## Product / Process Change Notification (PCN)

**PCN #:** PCN\_UtFLEX\_20220214

**Affected Series:** WE-FLEX+ ETD39; 7491973x1

Previous Packaging:

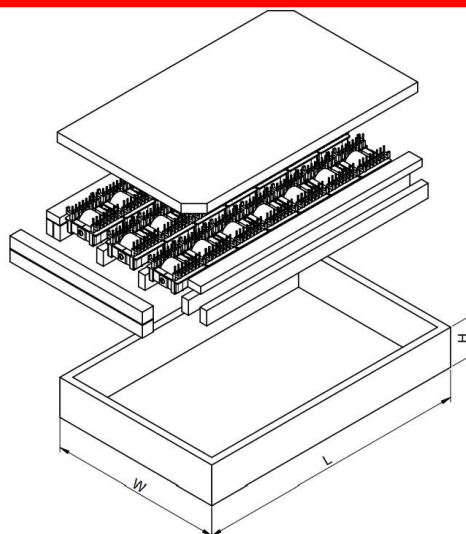
The previous packaging was a cardboard box and foam. The new packaging will be a tray. Please see the next page for quantities the packaging can hold and the views of the packaging's. The previous packaging will be shown in the red box and the new packaging will be shown in the green box.

Tray quantity: 21 pcs

Box quantity: 105 pcs
